**ZONING AMENDMENT,  
PLANNED UNIT DEVELOPMENT &  
SUBDIVISION STAFF REPORT**

**Date: April 15, 2004**

O. A. Pesnell, Jr.

REQUEST Rezoning, PUD and Subdivision

# SITE PLAN

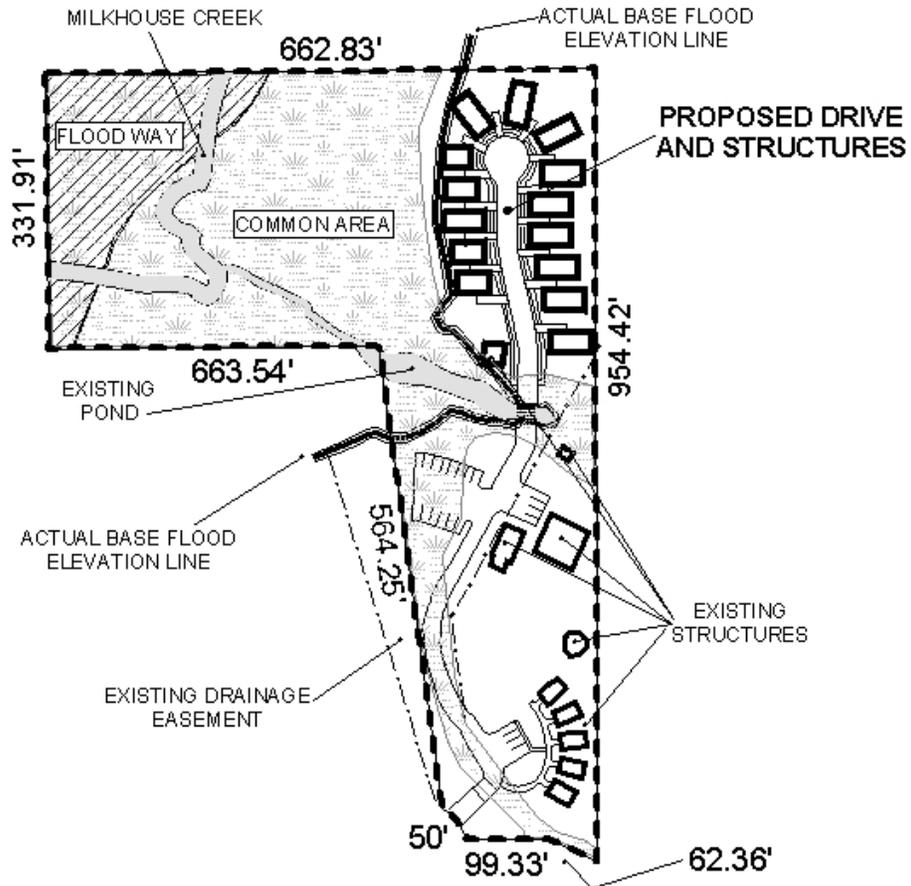
The southern portion of the site is currently developed with five homes, a chapel and clubhouse. This existing development obtained parking surface and driveway width variances to allow gravel parking and an 18-foot wide driveway. Gravel is not an approved paving surface and two-way driveways require a minimum width of 24-feet.

When the parking surface and driveway variances were approved, the proposed development (14 new homes on the northern portion of the site) was not illustrated on the site plan. While vehicular traffic to the existing chapel and clubhouse is not intense, 14 new homes would generate daily traffic on this driveway; therefore, the driveway should be paved with asphalt or concrete, and increased to a minimum width of 24-feet.

In terms of building spacing, only 13-15 feet is proposed between buildings, thus no windows would be allowed on the side of a building that would face a neighboring building. While only one parking space per house is proposed, the Zoning Ordinance requires only one parking space per two dwelling units for elderly housing.

**Planned Unit Development** Based upon the preceding, this application is recommended for approval subject to the following conditions: 1) limited to the approved Planned Unit Development application; 2) provision of a six-foot wooden privacy fence where the site adjoins R-1 development; 3) the provision a drainage easement for the Milkhouse Creek Floodplain, as well as any necessary surveys and coordination thereof with the City Engineering Department; 4) approval of City Engineering, Traffic Engineering and the Bureau of Fire Prevention for any existing or proposed bridges/culverts prior to the issuance of any permits for new construction on the site; 5) that the driveway, from Pesnell Court to the north terminus, be widened to a minimum width of 24-feet and paved with asphalt or concrete; 6) that there be no windows on the side of a building that would face a neighboring building; 7) the approval of all applicable federal, state and local agencies; and 8) full compliance with all municipal codes and ordinances.
